23 March 1984

Pursuant to the course of action agreed upon during our phone conversation of 16 February 1984, we are forwarding the information requested by you for the licensing of the coal-slurry sensors. In addition, we are providing information on the seven items requested by James W. Patterson; copy of the letter enclosed. These radiation safety and radiation handling data are related to an application for an amendment to License No. 37-1712-11. The license and amendment are to authorize use of custom radiation gauging devices manufactured by Science Applications, Inc.

## RESPONSE TO THE SEVEN ITEMS ADDRESSED BY JAMES W. PATTERSON

RESPONSE TO 6/21/84 LETTER  
OF  
JAMES W. PATTERSON (U.S. NRC)  
TO  
GLENN C. PRITCHARD (DEPT. OF INTERIOR)

FIGURE 1 6" GAMMA GAUGE

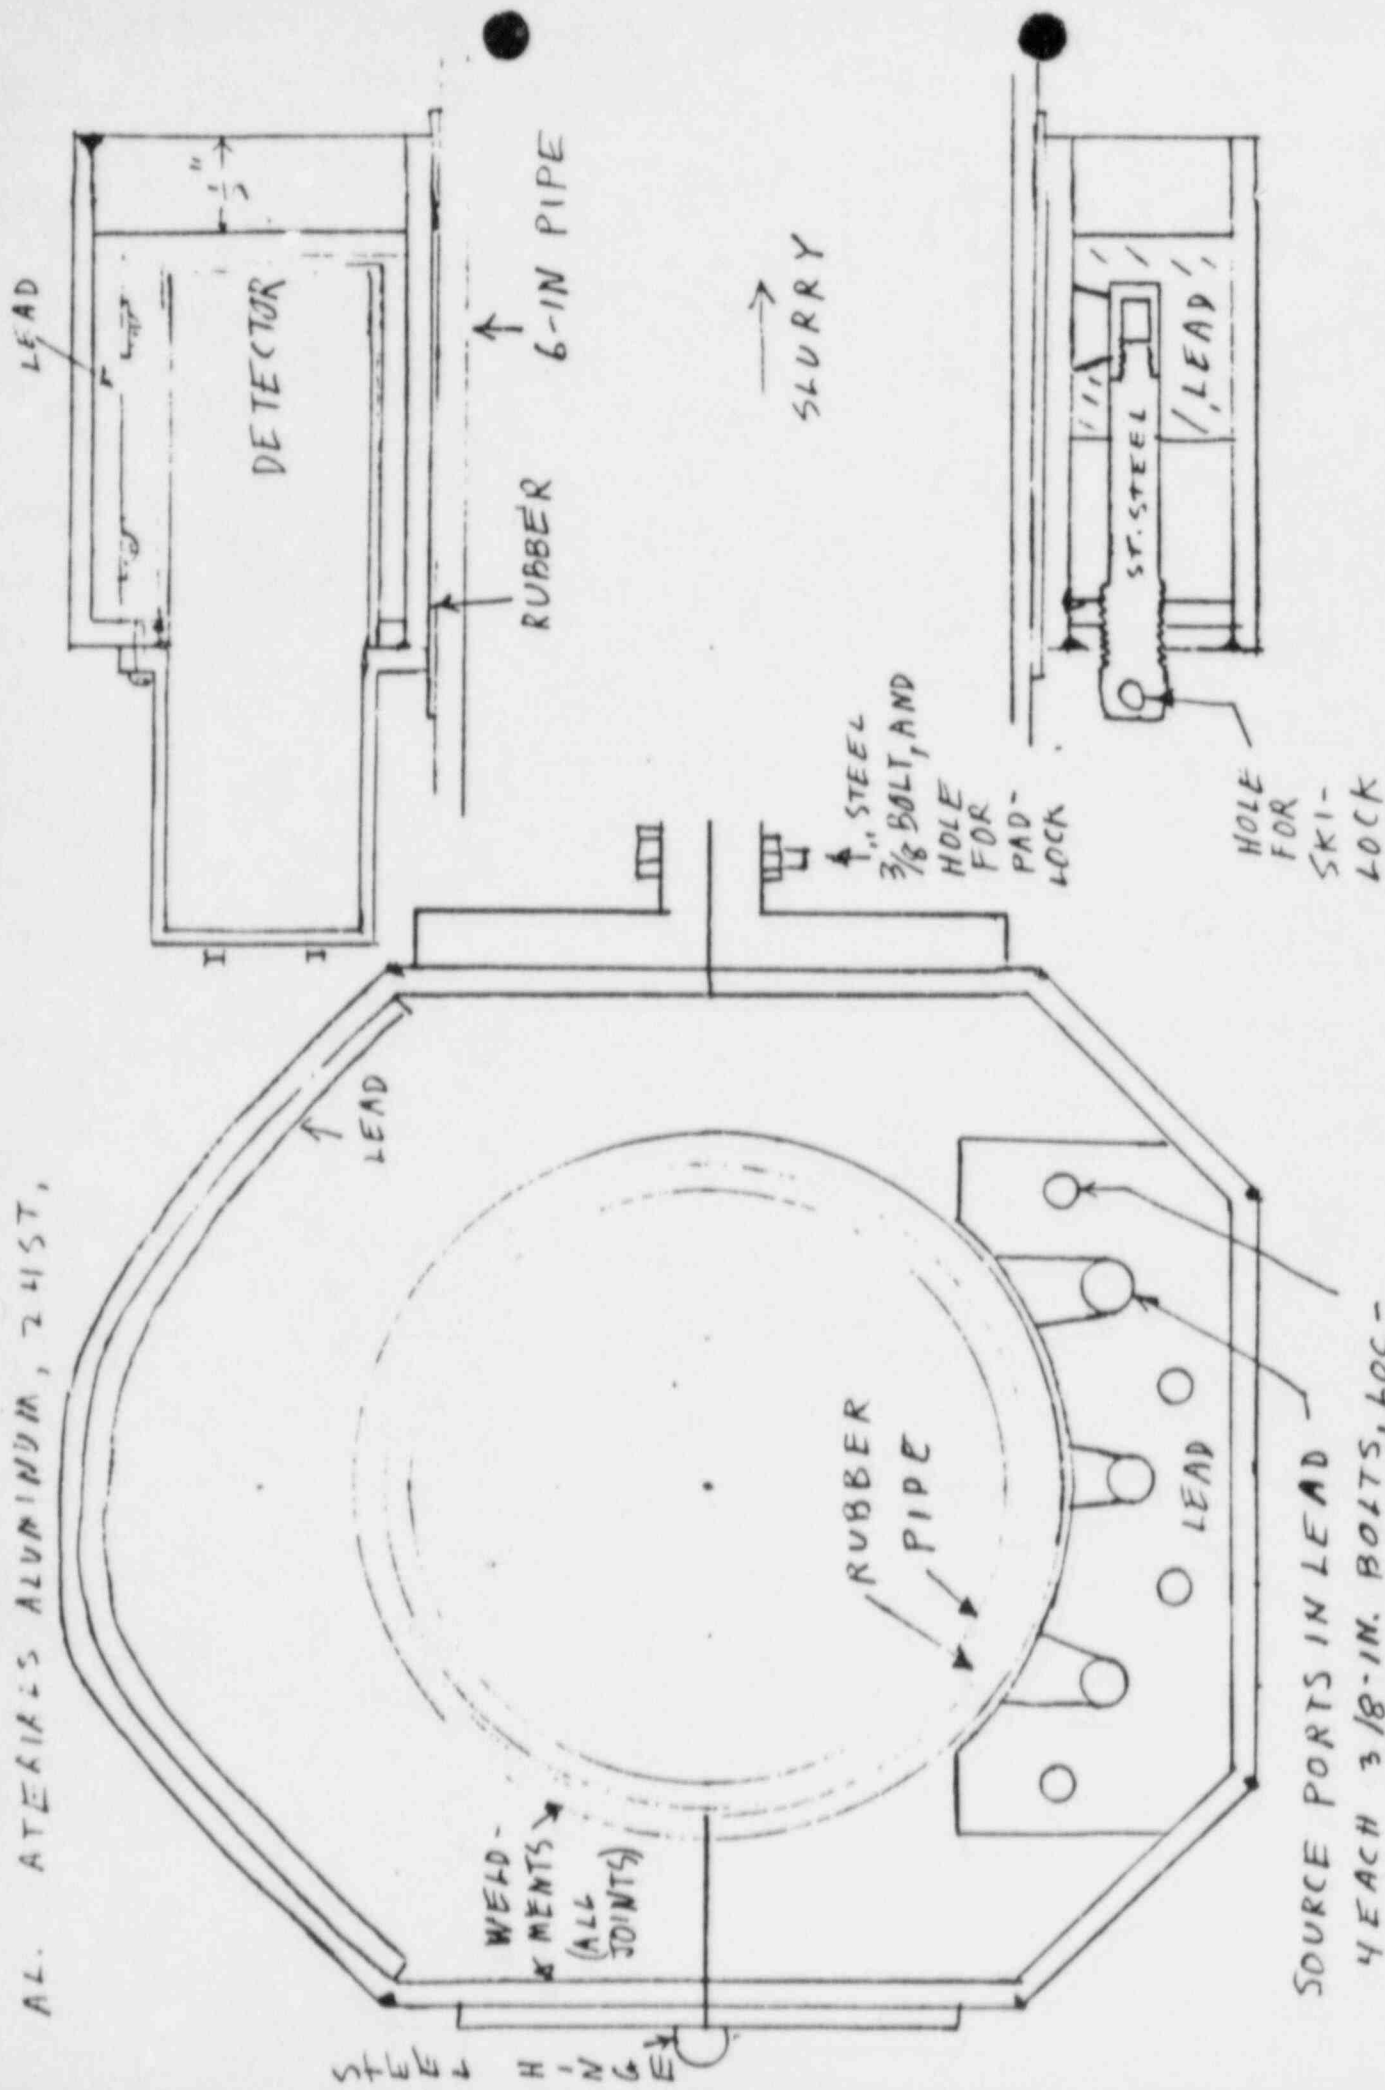
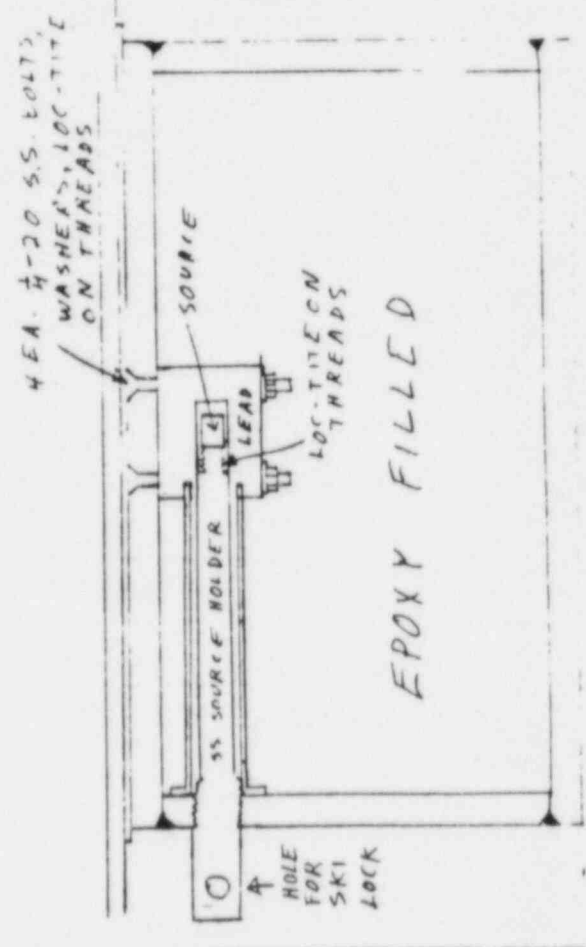
Details of construction of the source housings are shown in Figures 1, 2, 3, and 4. The specific pipe sections (spool pieces) to which they are attached, and the location code, are shown in Figure 5.

FIGURE 5.

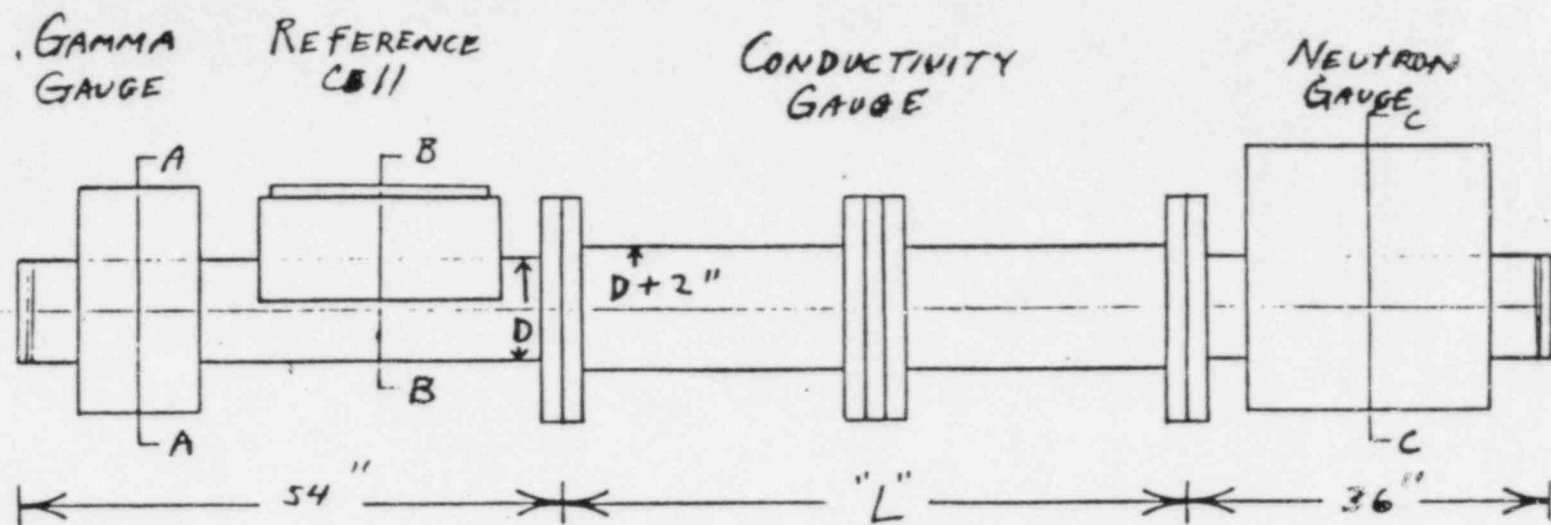
The lengths of the 6-inch, 10-inch, 12-inch, and 18-inch diameter pipe sections are shown in Figure 5.

FIGURE 6. SOURCE HOLDER  
FOR 6-IN GAMMA GAUGE

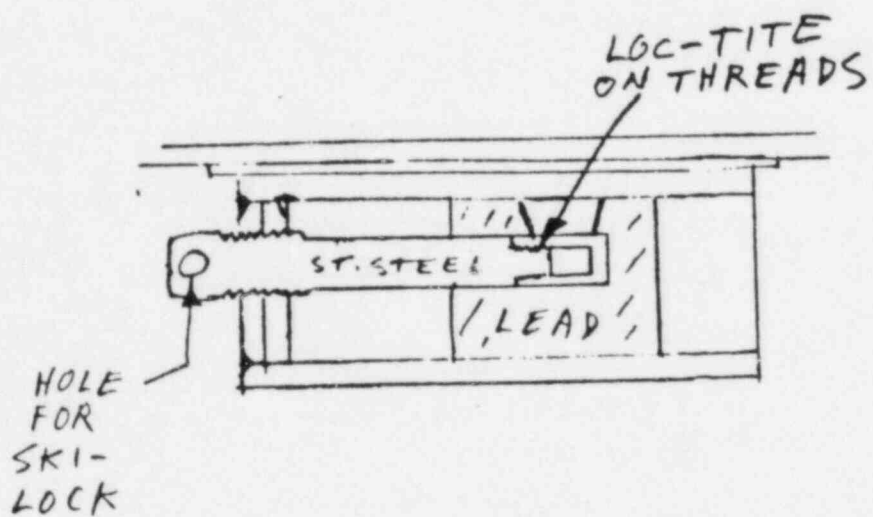
Details of construction of the source handles (rods) for the neutron and gamma-ray sources are shown in Figures 6, 7, 8 and 9. The method used to "identify the rods when loaded as to the specific californium or cesium sources that they contain" is shown in Figure 10.
